From: [REDACTED]
To: [Jones, Hefin](#)
Cc: [REDACTED]
Subject: SLP: Turfhill Park
Date: 20 February 2020 17:32:00
Attachments: [REDACTED]
Importance: High

The SLP – Heronscourt & Colville Gardens Residents Associations responses to the ExA' s Questions of the 12th December by Natural England and of the 13th January 2020 by the Applicant

ARGWEB Committee GIS for SARG

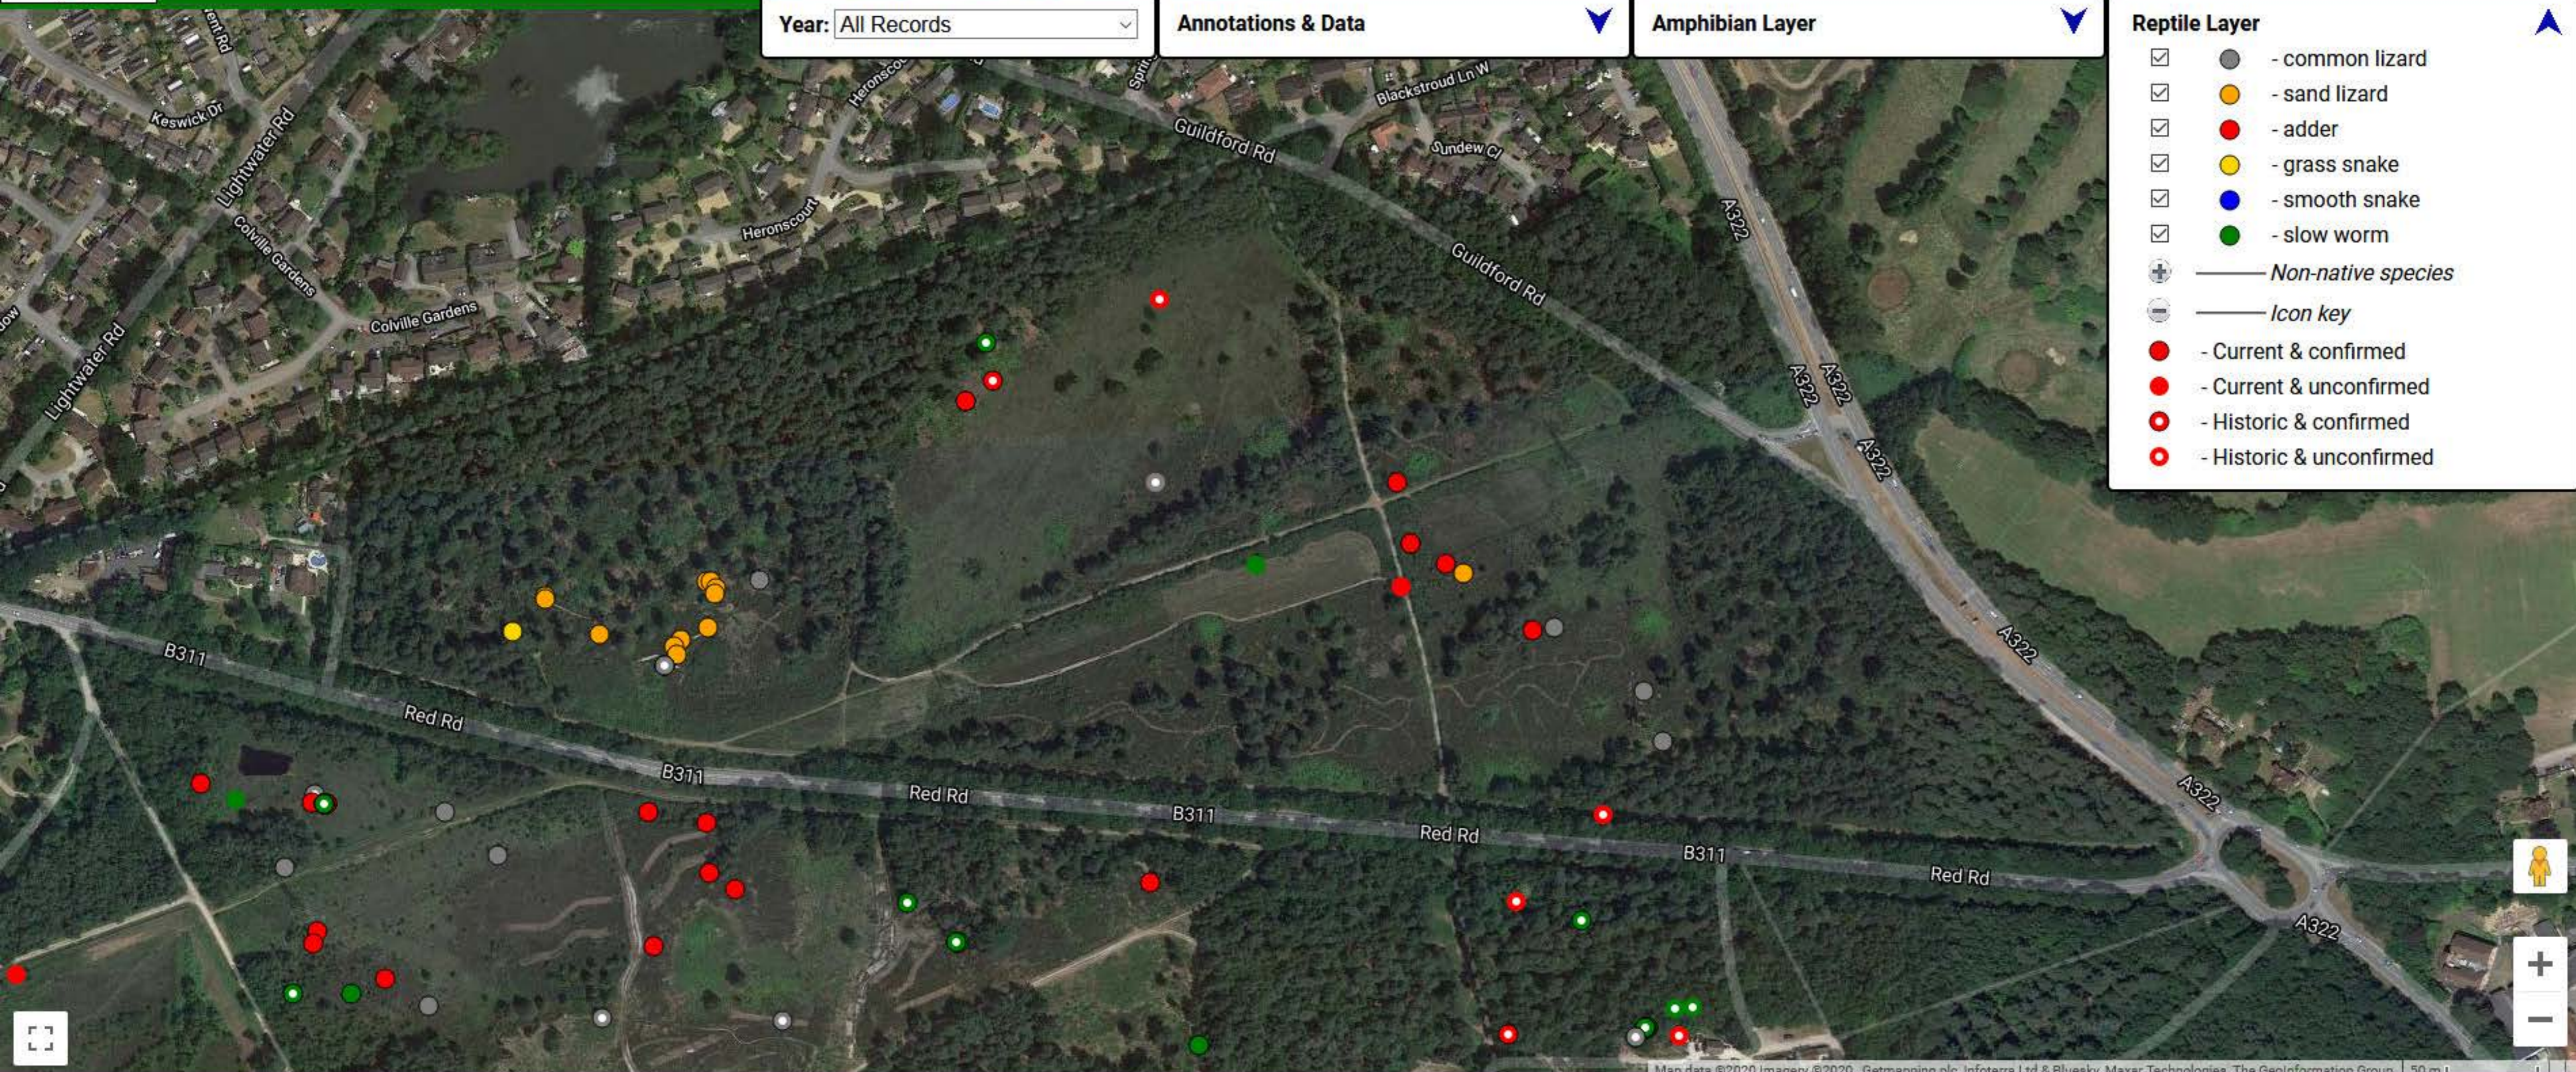
It is agreed that the habitat across the centre of Turfhill is suitable for sand lizards, however the Order Limits of F1c are not. Contrary to the Applicant's earlier statements that sand lizards had spread throughout the Park, the latest SARG sightings report and confirmed by the Applicant's map at 2.7 ii), only a single sand lizard has been recorded south of the access track well away from the Order Limits, which extend northwards from the centre line of F1c.

The fact that it has crossed and not remained in the area of F1c, confirms the total unsuitability of F1c for sand lizards occupation. Having checked the latest SARG records of sand lizard sightings, this solitary male is the only one to have made this journey. It is notable that apart from this single one, the concentration all other sightings, remain in the direct vicinity and slightly north of the Release Area.

The latest SARG mapping of sand lizards in Turfhill Park, is attached.
